**Columbia Hall Flooring Replacement Project  
Columbia, South Carolina  
University of South Carolina  
University Project Number H27-Z374**

**April 5, 2018**

**ADDENDUM No. 1**

**1**  
**ID2.2** TYPICAL RESIDENTIAL FLOOR - RENOVATION PLAN (FLOORS 2, 4 - 11)

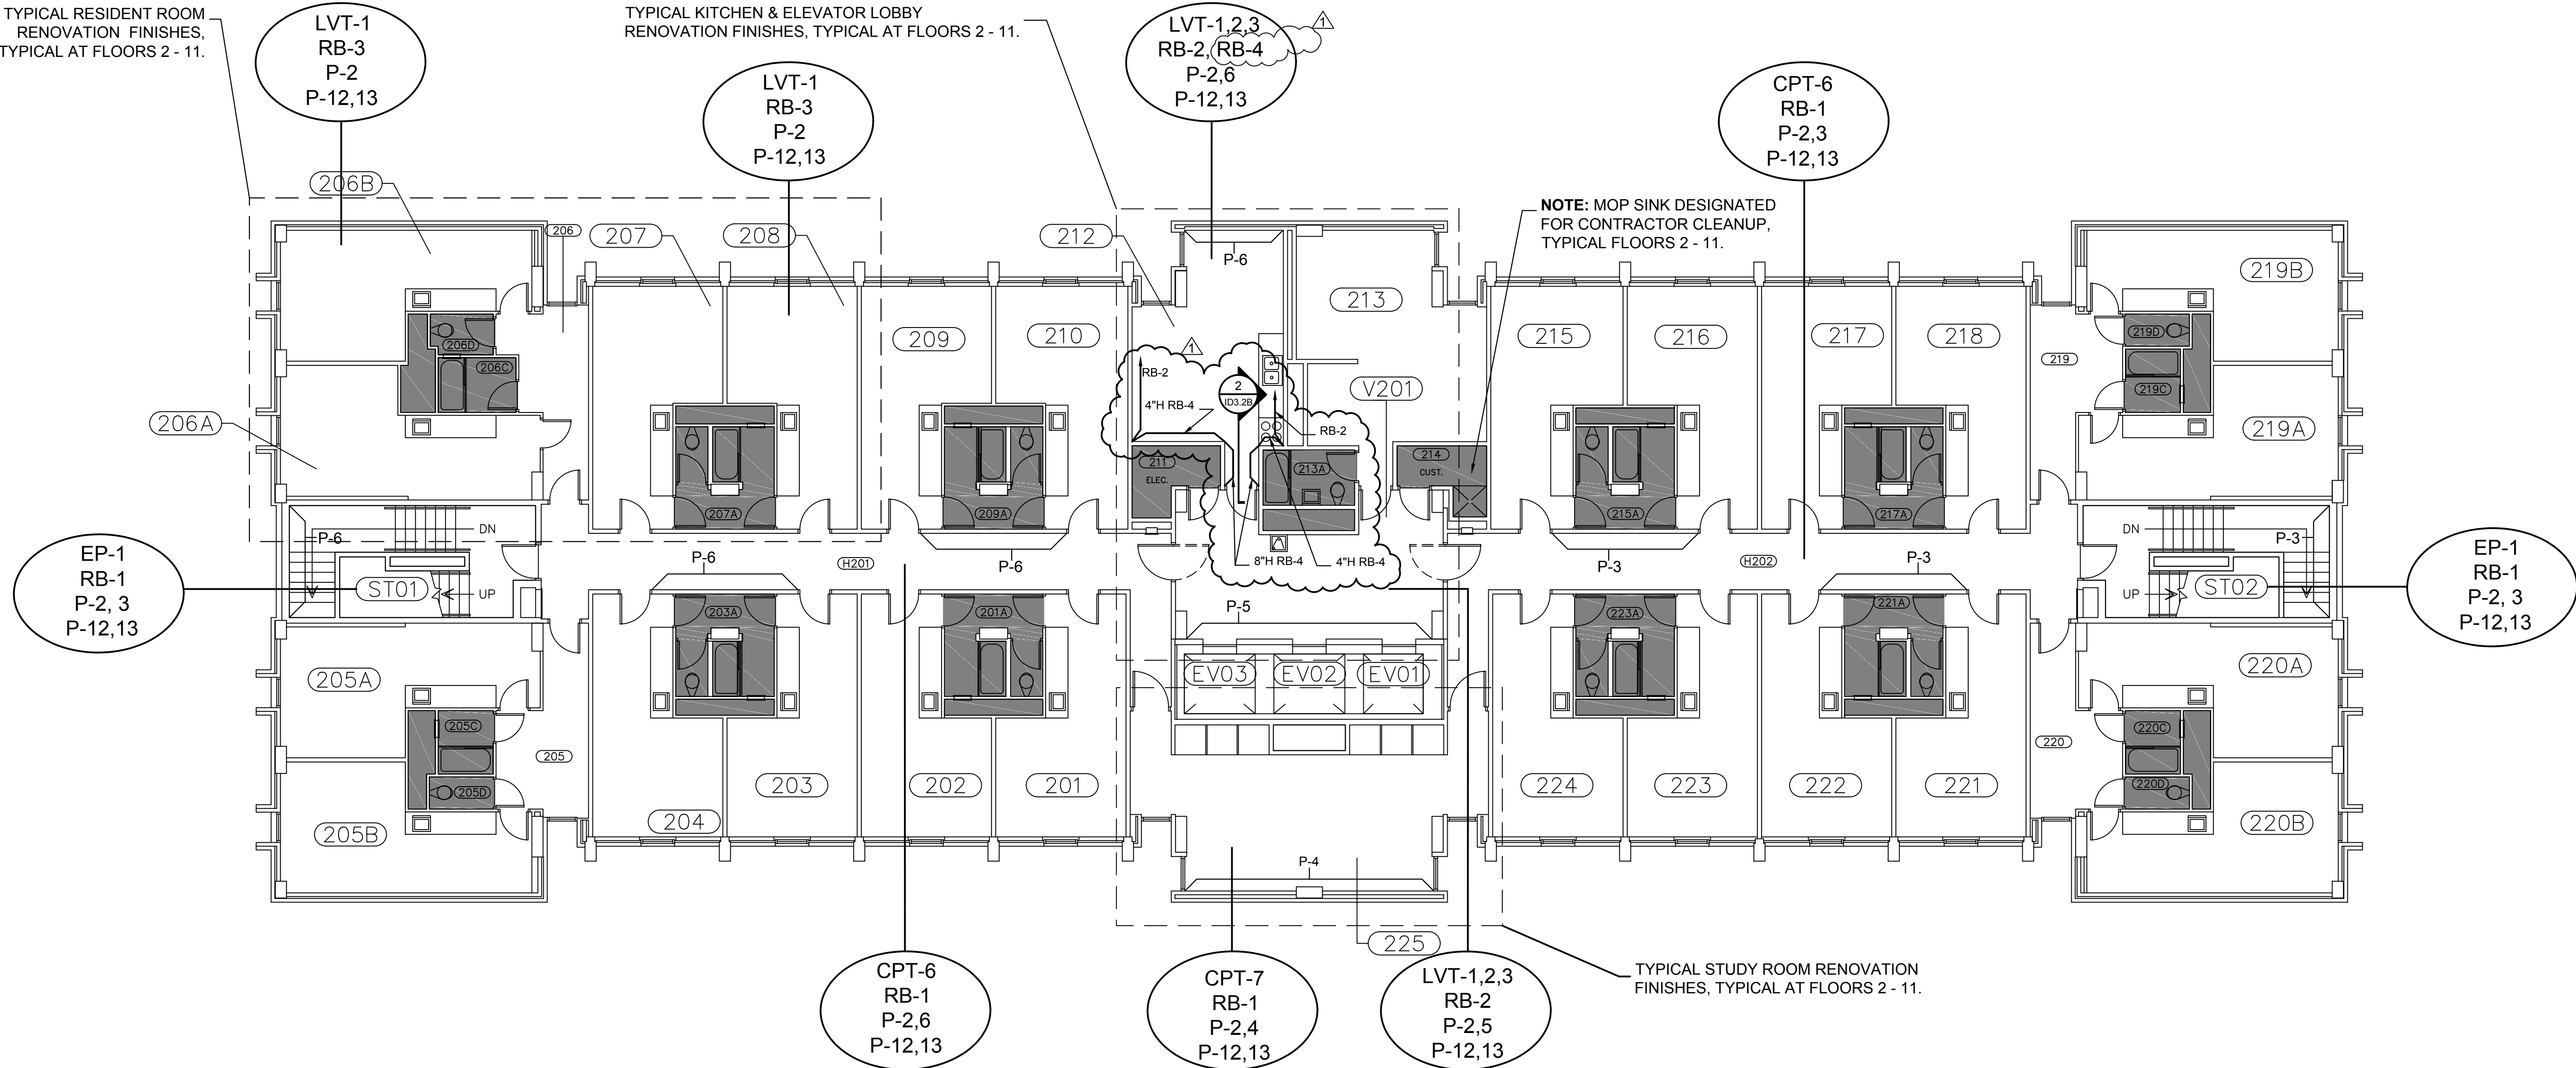
4. Where ceramic tile and mud bed are demoed at kitchen entry and ramped down on floors 2-11, the existing ceramic base line will be higher than the specified rubber base. How should that situation be addressed?

- a. Reference MODIFICATIONS TO SPECIFICATIONS, item 3, above.
6. Due to the removal of the mud bed in the kitchenette areas, we believe that the called for 4" base will not give you adequate coverage. You are removing approximately 1-1/2 to 2" of mud bed. Is 6" base a possibility?

- a. Refer to drawing ID2.2, dated 3-20-2018, revised 4-5-2018 and ID3.2B, dated 3-20-2018, revised 4-5-2018 for additional details.
5. Is the following Terrazzo scope of work correct?

- a. Refer to drawing ID2.2, dated 3-20-2018, revised 4-5-2018 and ID3.2B, dated 3-20-2018, revised 4-5-2018 for additional details.
7. Is the furniture and washer/dryer combo in the RA unit on the 1st floor on the flooring companies scope of work to be removed?

ID3.2B

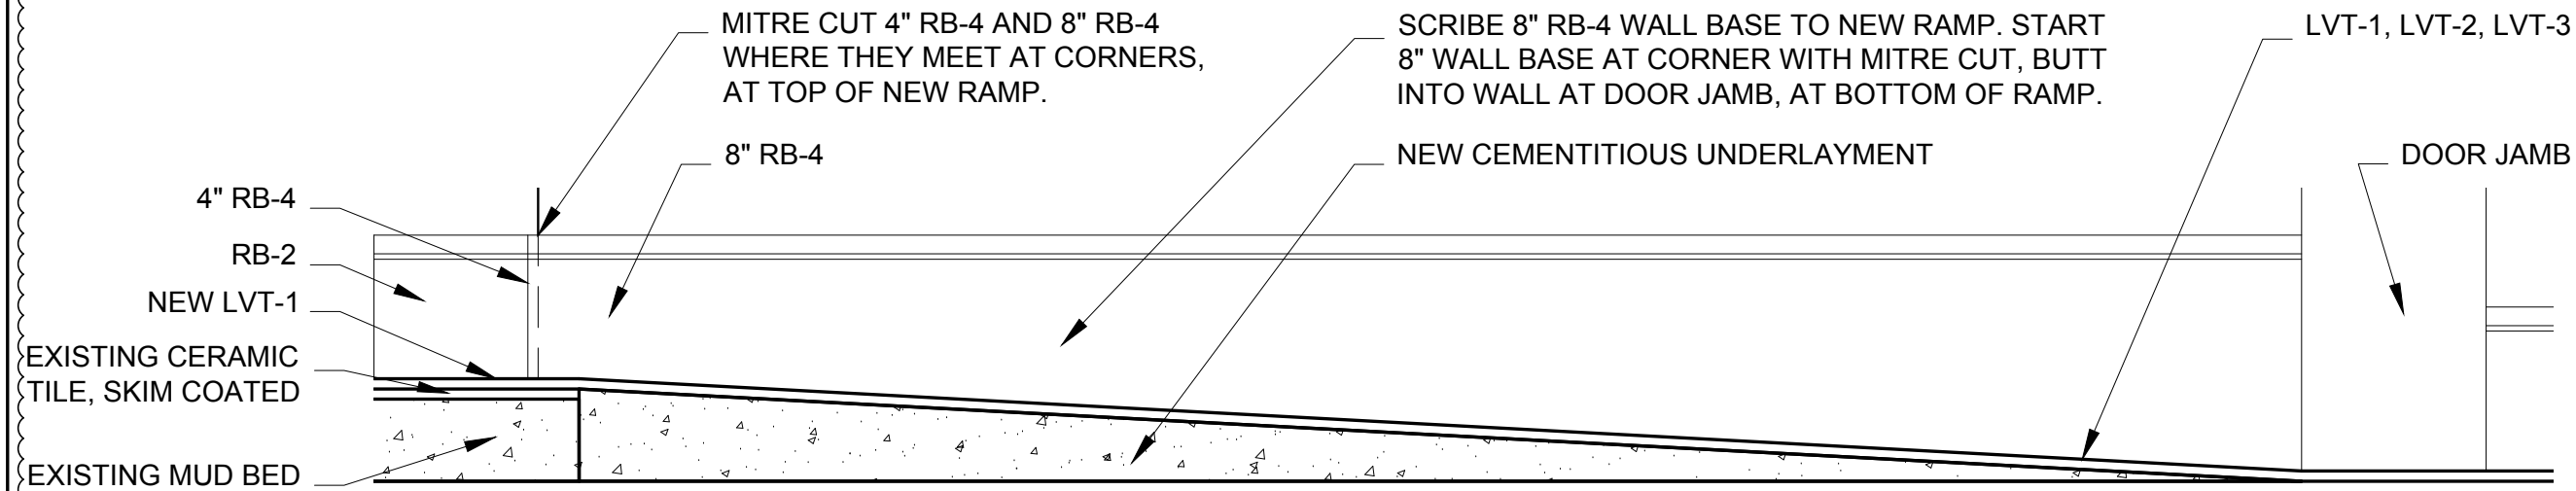
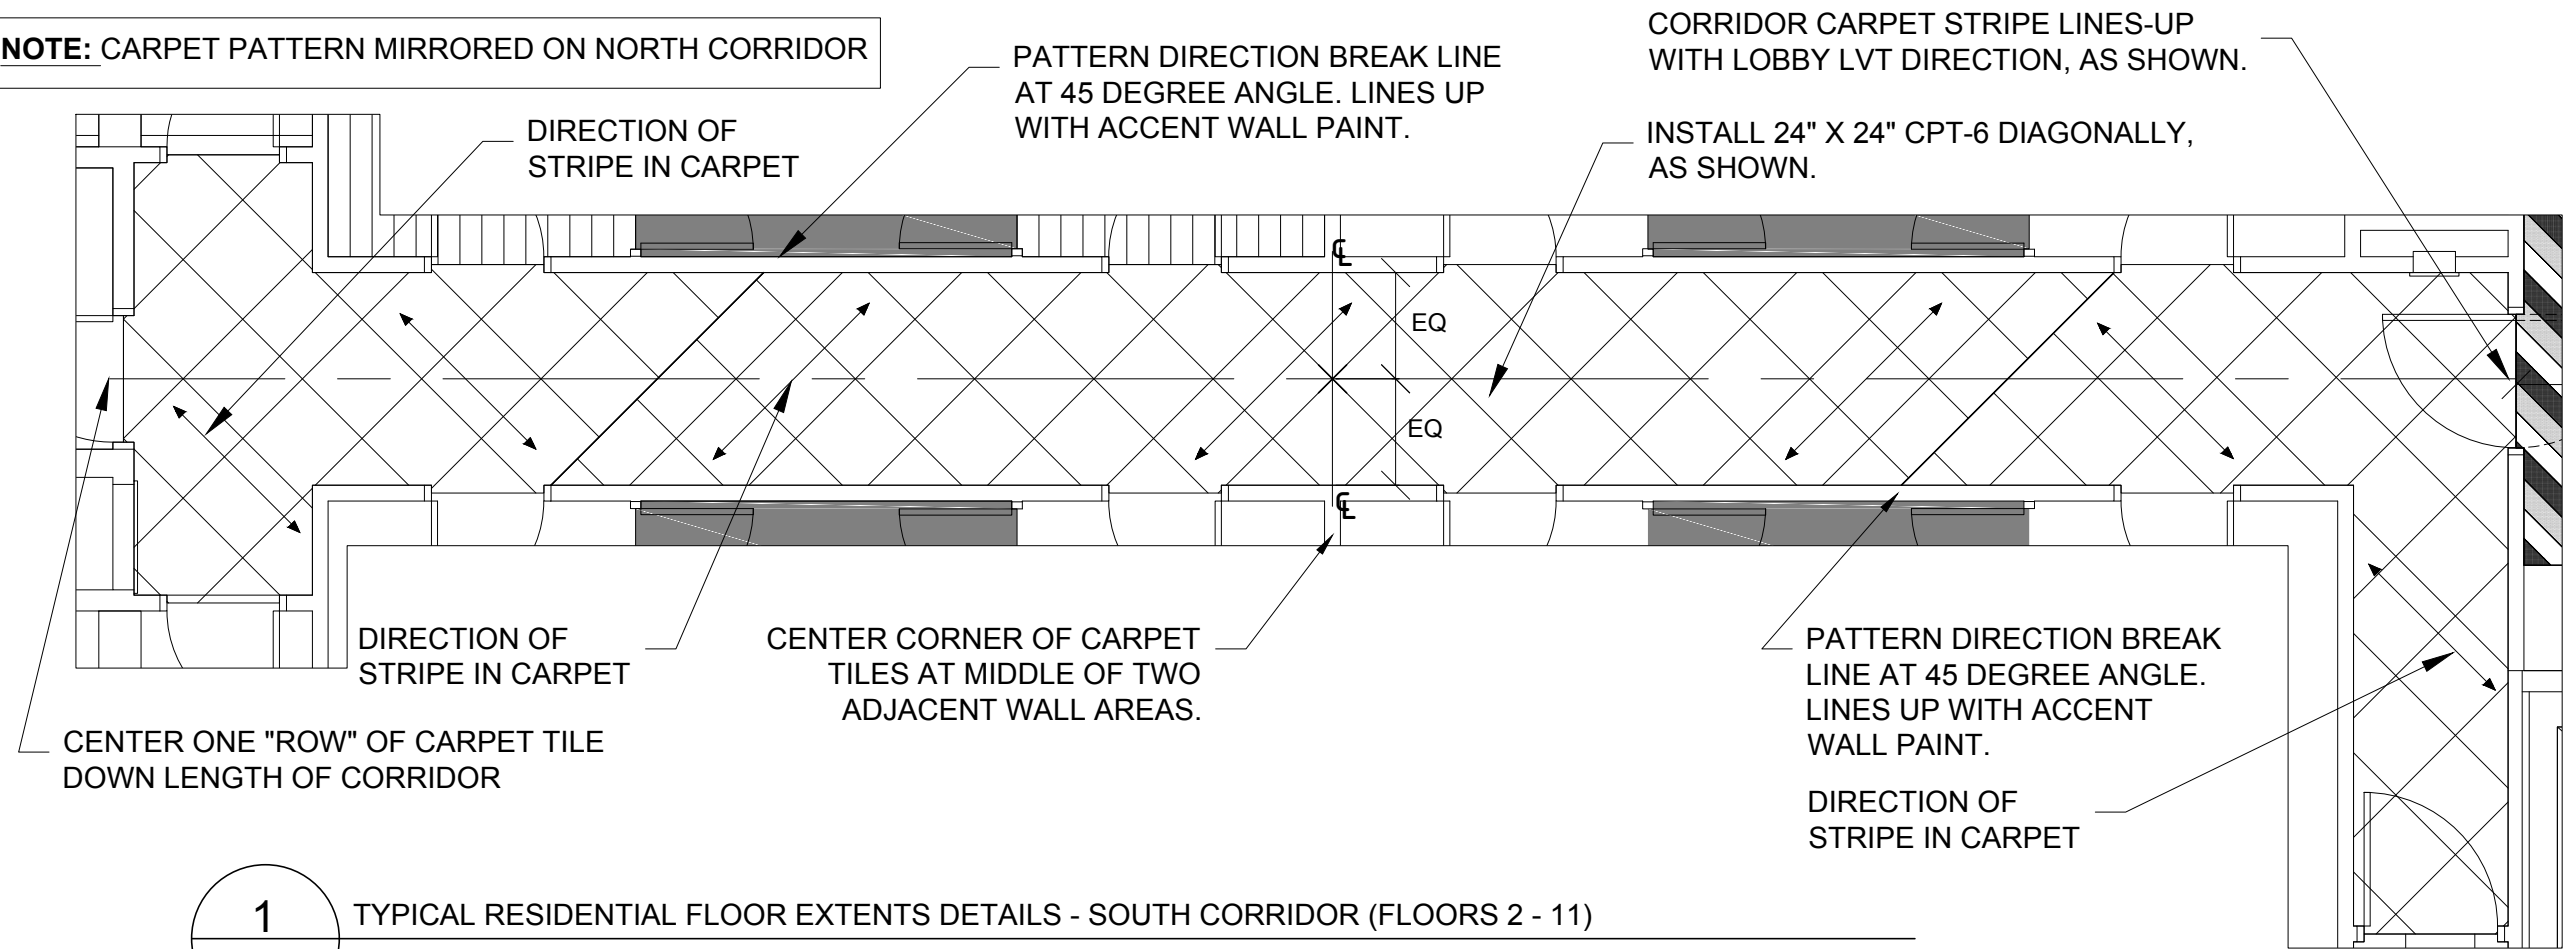
Coordination of exact specifications and performance requirements to be coordinated with the awarded contractor prior to the start of construction. Refer to drawing ID3.2B, dated 3-20-2018, revised 4-5-2018 for approximate locations of the intended work indicated above."
